## Firmware 2.06.3 bug list:

## List of bugs/improvement requests

FPGA design revision 83E9:

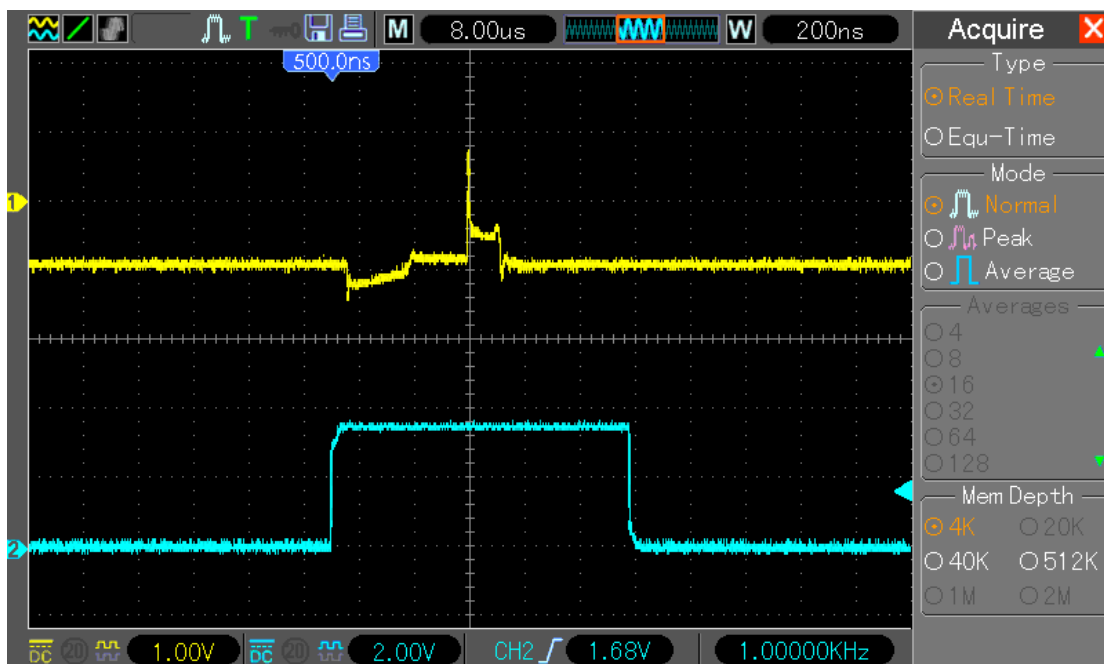
4. Digital Filters to be implemented.
5. SDK to be released
6. Update FPGA design to match ADC skew/timings in 125MHz/1GSs mode (this is already known issue and listed in old “issue list”, posting once again in this list as reminder)  
FPGA design revision 83E8 sample rate 1GS/s clocks skew (must be always 1000ps):

not yet measured, but Hantek statement *"It's impossible for us to achieve it now"* is not really optimistic.

6. There is no affordable workaround for now. Changes to hardware are possible but expensive. I've tested Silicon Labs jitter cleaner, Murata LDHxxx delay lines and a combination of other solutions. I was more than satisfied with achieved results, expect the costs.  
For now we have to use what available, both manufacturers developed within last 2 years few FPGA design versions, the best is from upcoming Tekway MST DSOs and Hantek Handhelds – however they not allowing dual channel 500MS/s sampling in long memory; Hantek's bench DSO hw1007 83E9 design allows such faster sampling but the skew is still far from perfect. I did publish all these FPGA designs, you can play with them to which is best for you. **But note – do not do this when you own hw1005 DSO, they can't be modified!**  
For those of you who don't know what this bug means – Google for waveform/interleave distortion and/or Agilent 5989-5732EN.

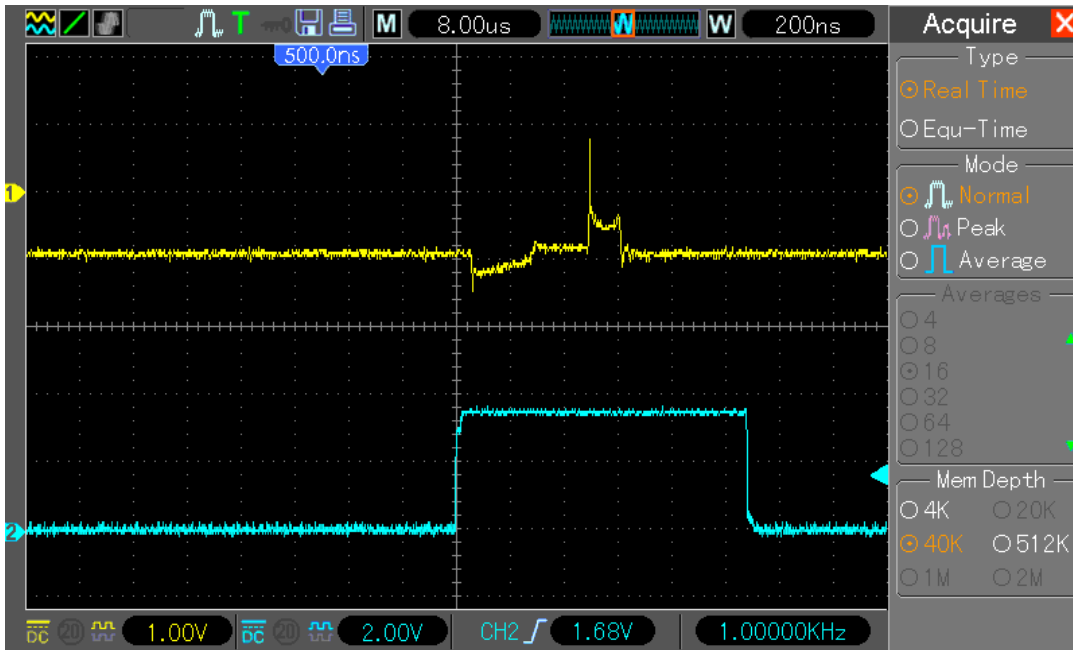
8. In single window, sample memory  $\geq 40k$ , both channels (ch1, ch2) enabled and time base from 400ns/div up to 2ns/div the position change (fine and coarse) control is not working. Only scale is moving, but not the waveform. See attached picture to understand issue:

with 4k memory when changing position waveform is moving

with 40k and above, when moving changing time base position waveform is NOT moving when in RUN mode (but works in STOP mode)

7. This is improvement proposal and not a bug. It has been removed from to-do as “not important”.
8. **This is a very unfortunate bug; possible workaround is to use dual window mode or less memory depth (both with disadvantages)**

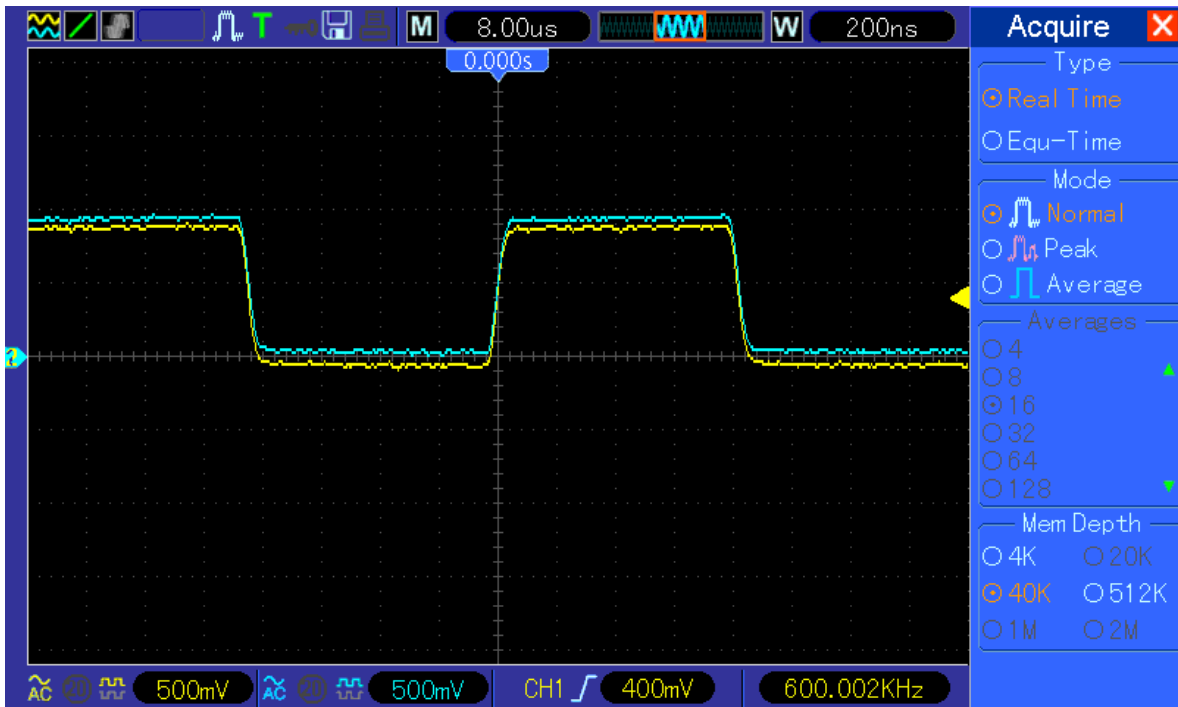
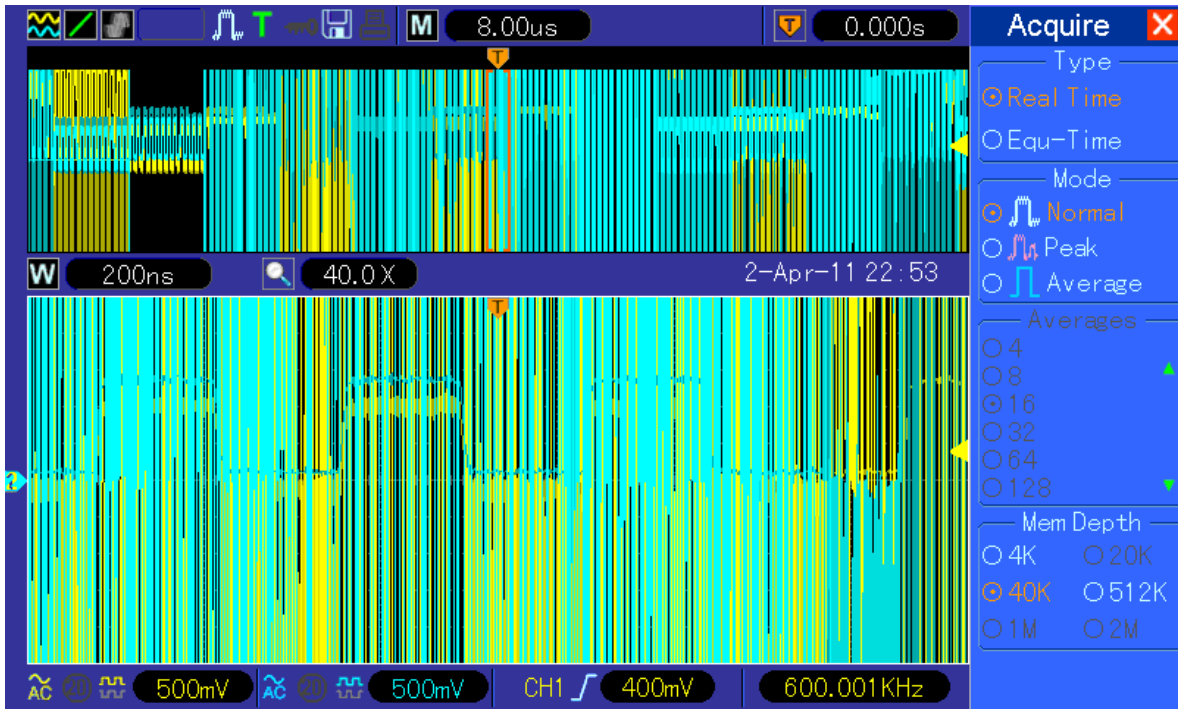
9. In single window mode, sample memory 40k, both channels (ch1, ch2) enabled – while switching to dual window mode artifacts on screen and DSO later crashing and not responding.

**Artifacts disappear when changing timebase just after switch to dual window, so just an init error?**

Set like on picture

and switch dual window mode to see artifacts like this:

9. ~~Workaround is to change Timebase (just one step forward and back) right after dual window enabled. Note – the main window (top) need to be activated, the bug have something to do with main TB buffer initialization.~~

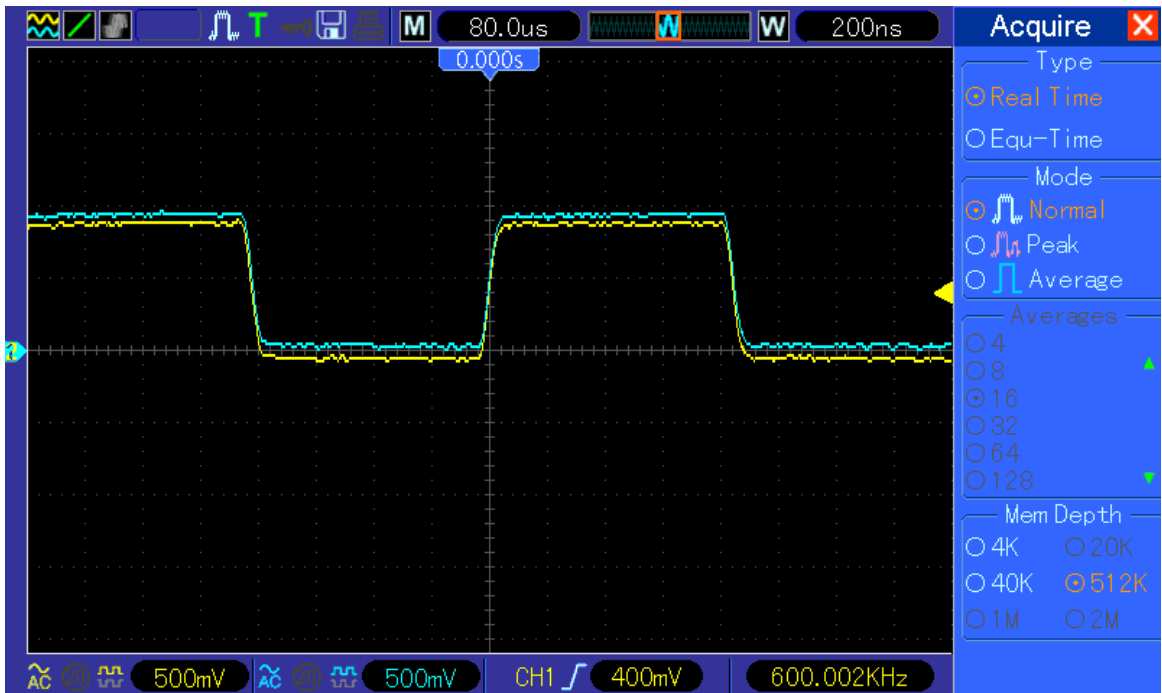
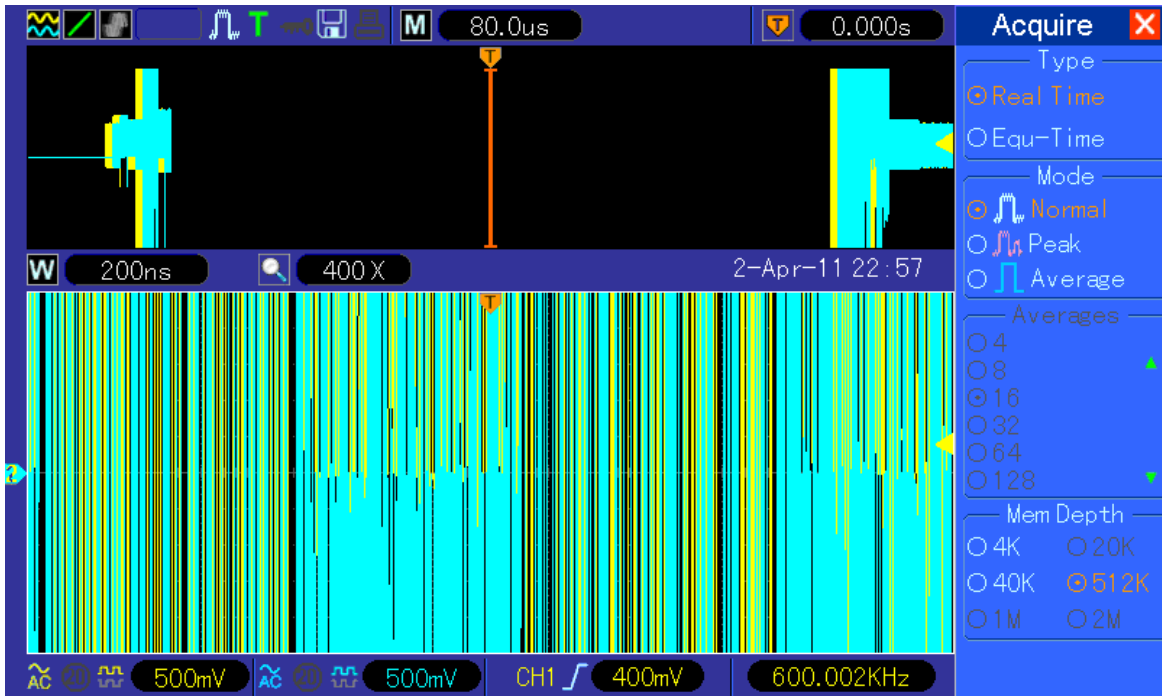
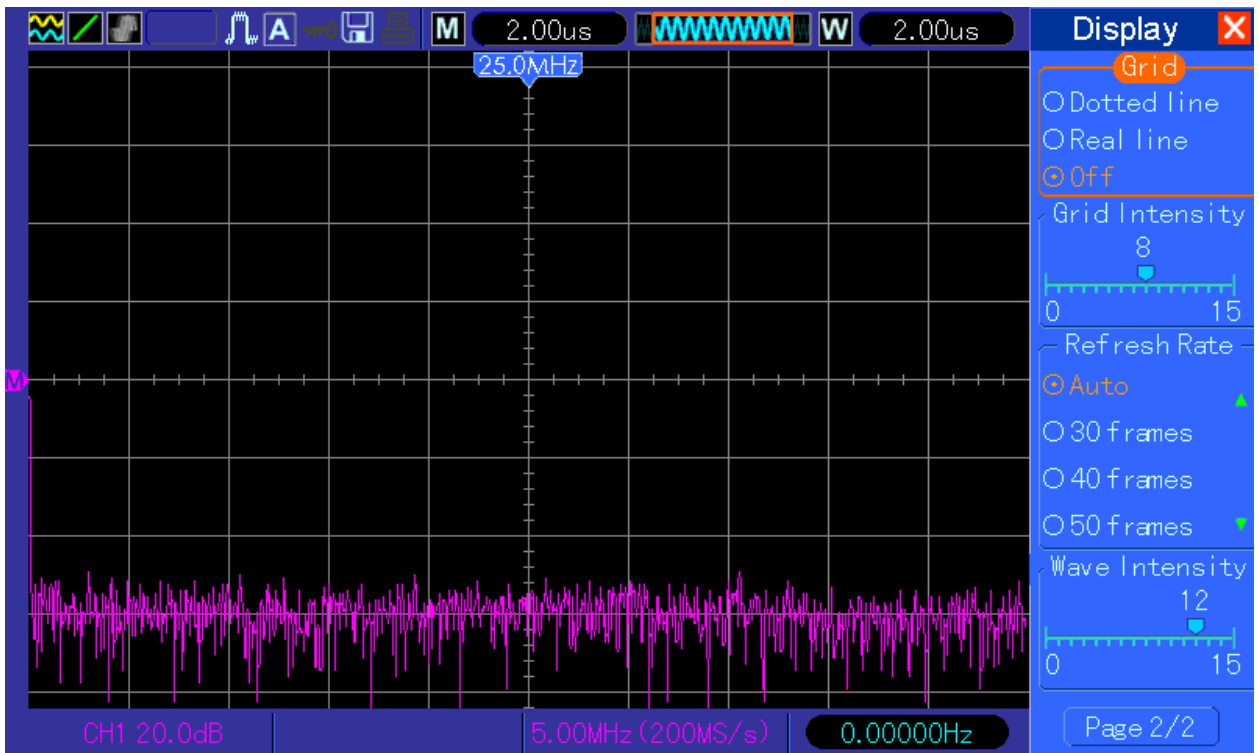
10. In single window mode, sample memory 512k, both channels (ch1, ch2) enabled – when switching to dual window mode artifacts on screen and DSO later crashing and not responding

**Artifacts disappear when changing timebase just after switch to dual window, so just an init error?**

Set DSO like on picture

and switch dual window mode to see artifacts like this:

10. Workaround is to change Timebase (just one step forward and back) right after dual window enabled. Note — the main window (top) need to be activated, the bug have something to do with main TB buffer initialization.
11. This is improvement proposal and not a bug.
12. Use my firmware (2.06.3\_120507.6), I removed that bug.
13. Use DC trigger coupling or “add offset” when you set trigger point. On some other good known DSOs (e.g. Tektronix TDS7xxx) there is exact the same DC-signal/AC-trigger “dependency” (bug) and nobody ever complained about.

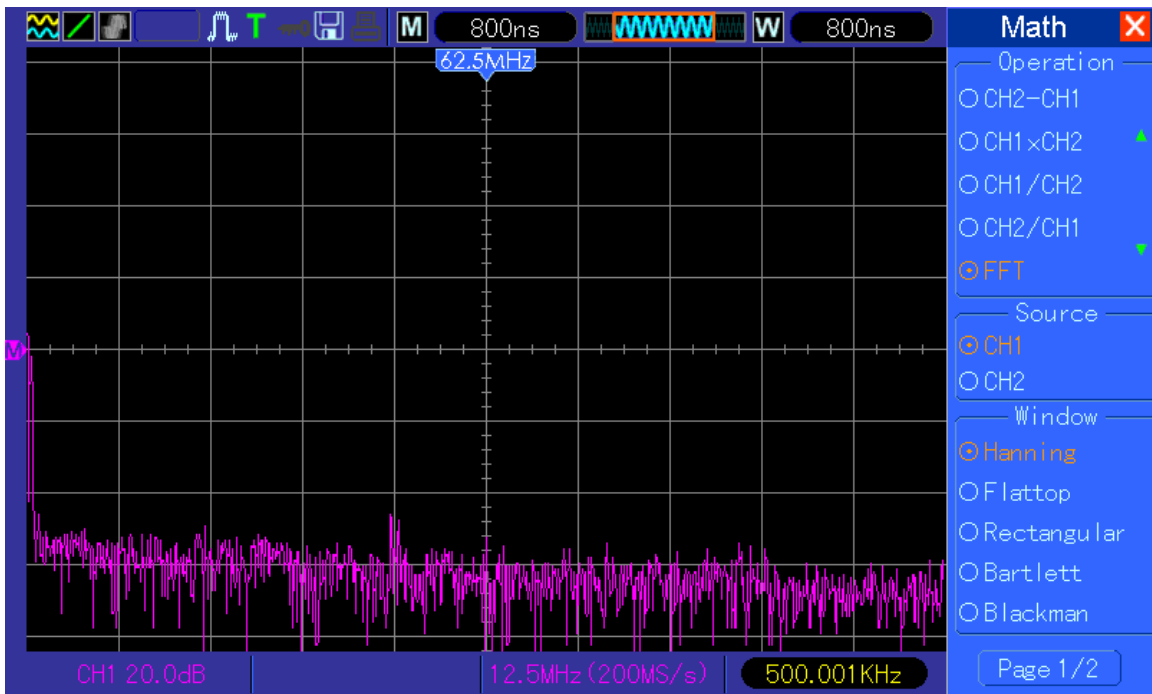
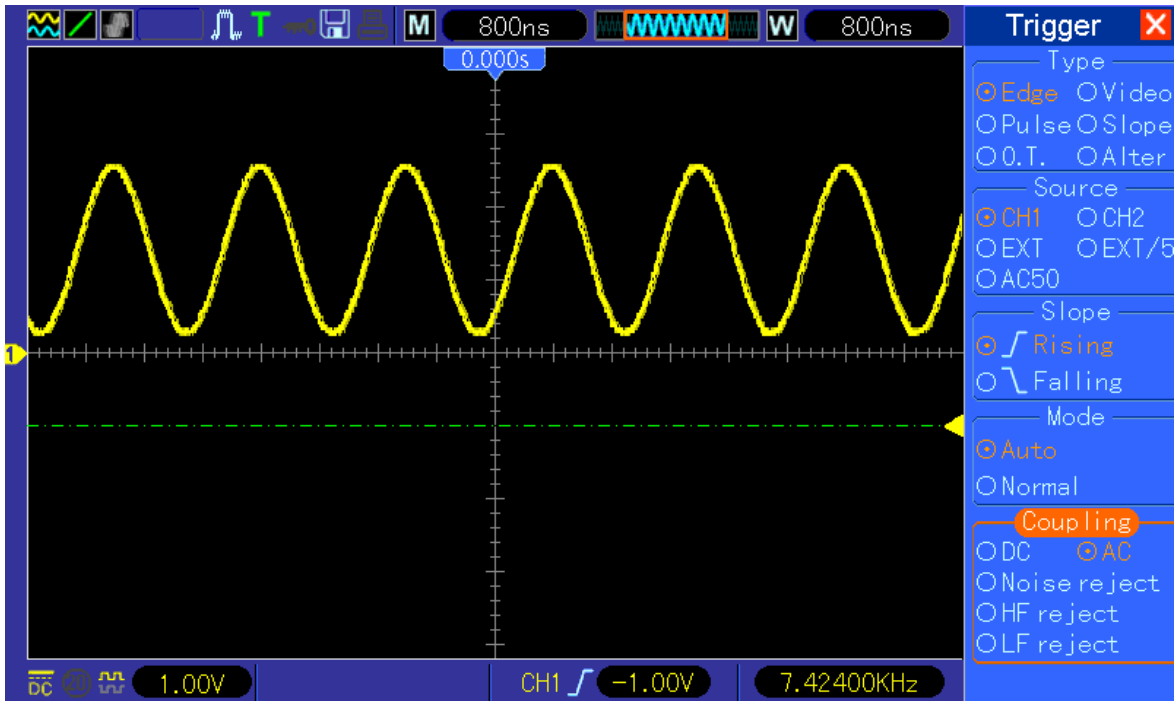
12. In FFT mode “Full span” is higher than Nyquist (sample rate / 2 )  
 Example: 800ns/DIV, sample rate is 200MSs, full span 125MHz. Easy to fix by enabling from

800ns/DIV to 20ns/DIV 1GSs sampling (when 4k memory or FFT enabled)
